PATTERSON LAKE ADDITION

WICHITA, SEDGWICK COUNTY, KANSAS

Re: S/D 95-12 - PATTERSON LAKE ADDITION (Final Plat)

STAFF REPORT
(Final Plat Approved 2/16/95)

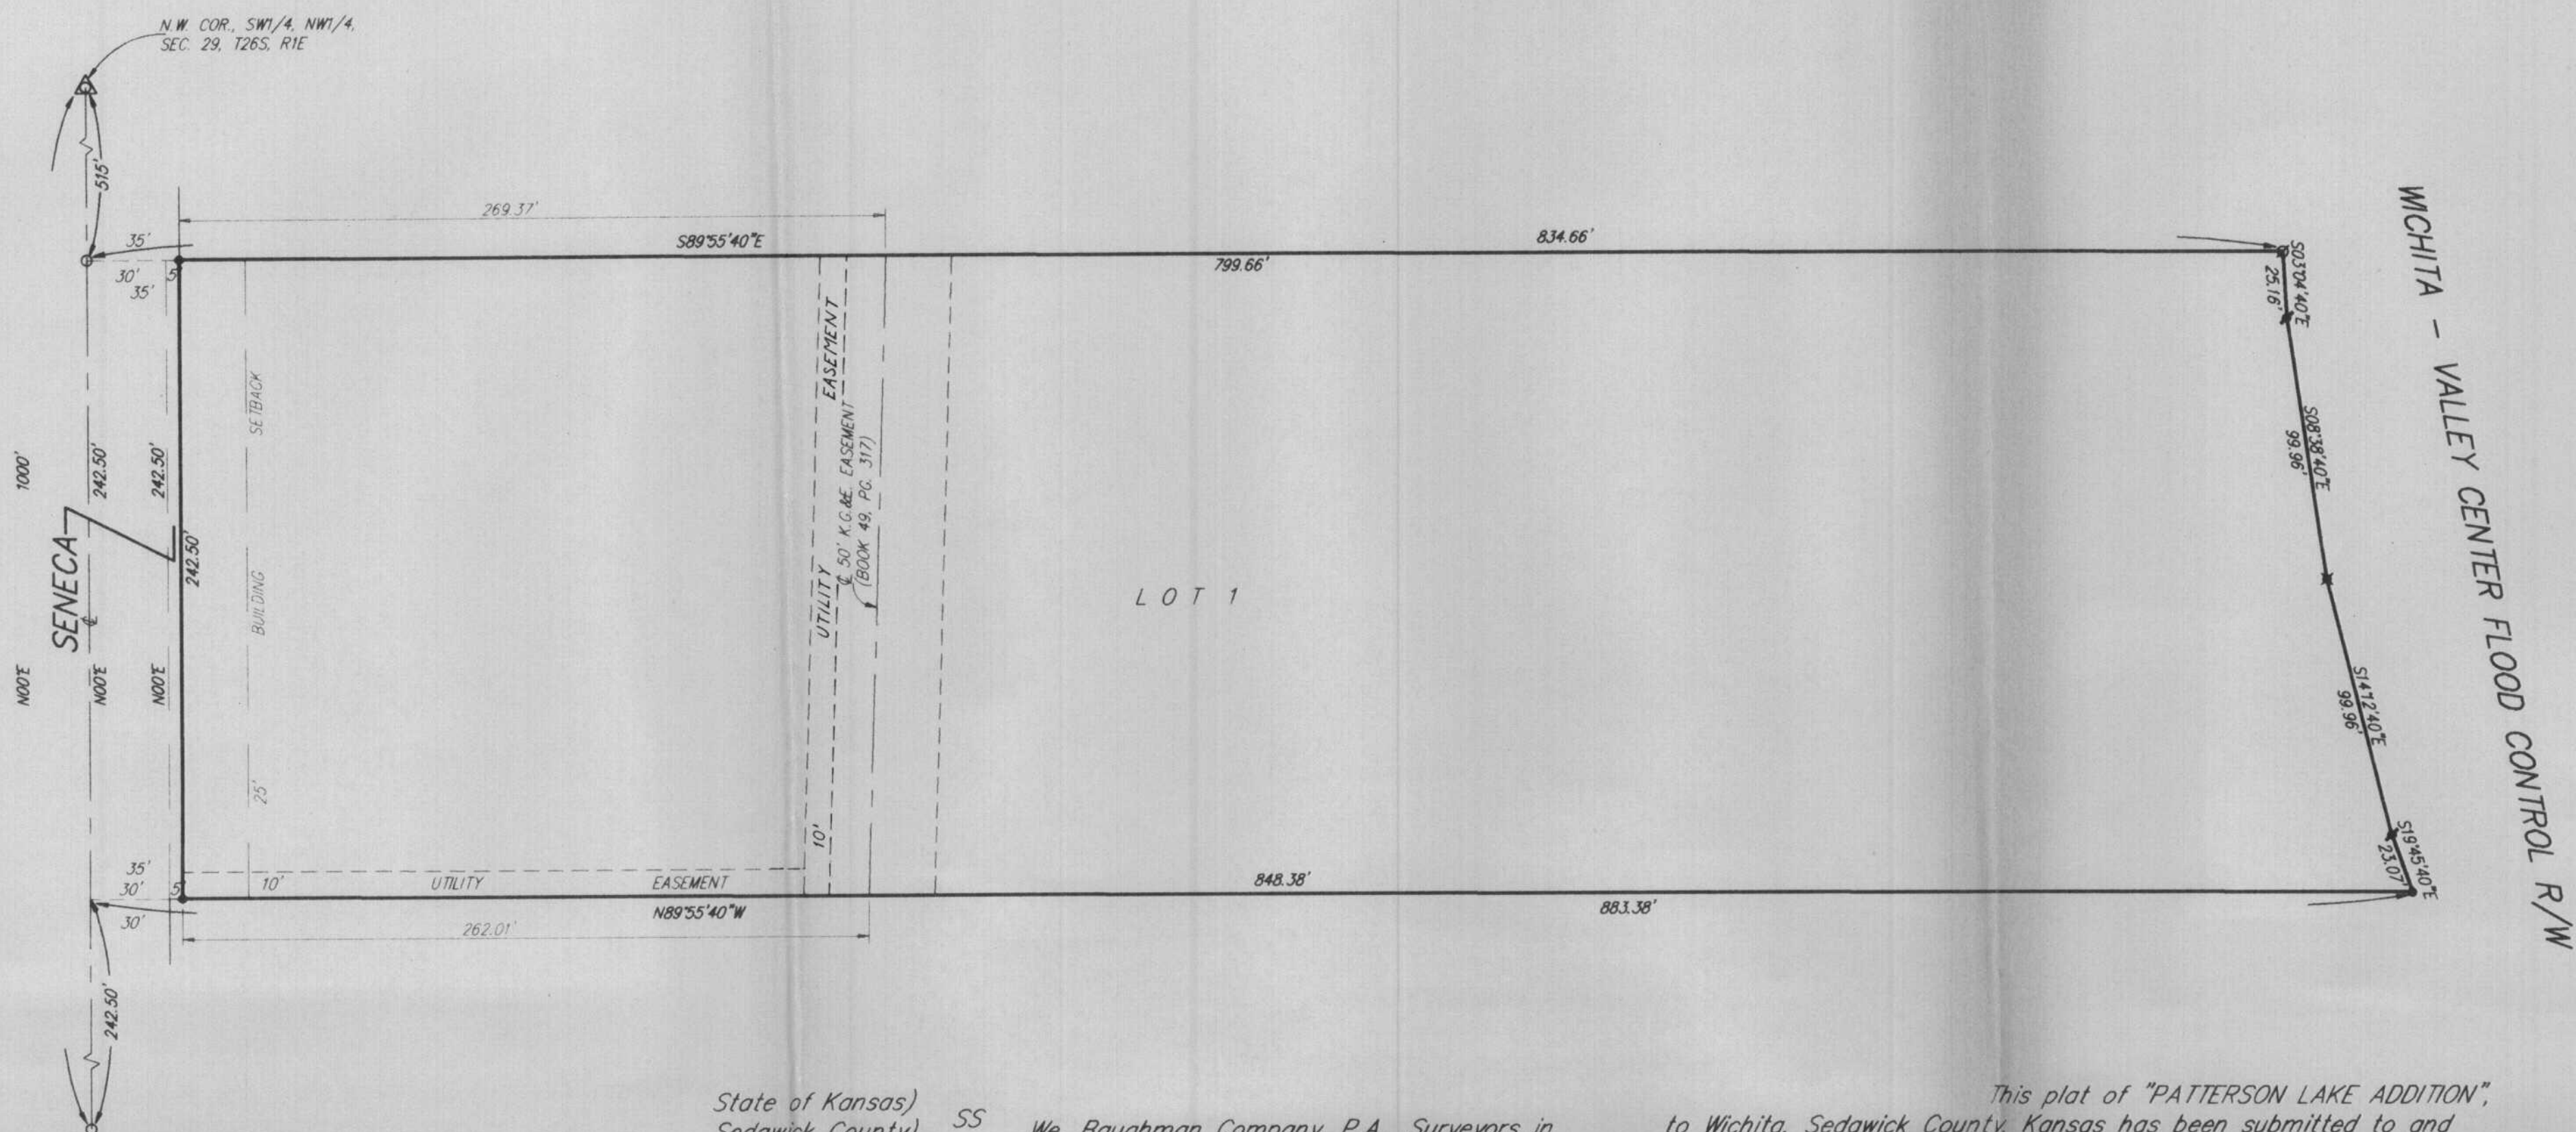
- ~~D.~~ As noted by Engineering minimum building pad elevations shall be established for this site. The final plat tracing shall provide proper documentation and related information (note in plat's text, benchmarks, City datum & MSL, etc.).

- ~~F.~~ Prior to this plat being released for recording, the shed indicated within the 25-foot setback shall be removed. A letter shall be submitted to Planning indicating removal of the shed. The applicant is also advised that the indicated carport at this site could be in violation of the required sideyard setback. If the carport and existing garage remain detached from any

future residence, a three (3) foot sideyard is typically required. If attached to a residence or if the garage were converted to a residence, a six (6) foot sideyard would be needed. Any such violation would require approval of a variance by the BZA.

OK slwamy
G. The final plat shall indicate the utility easements requested by Southwestern Bell which are indicated on the enclosed "marked" copy of the plat.

MINIMUM BUILDING PAD ELEVATION FOR LOWEST OPENING TO STRUCTURES		
LOT	M.S.L.	CITY DATUM
1	1324.0	136.6
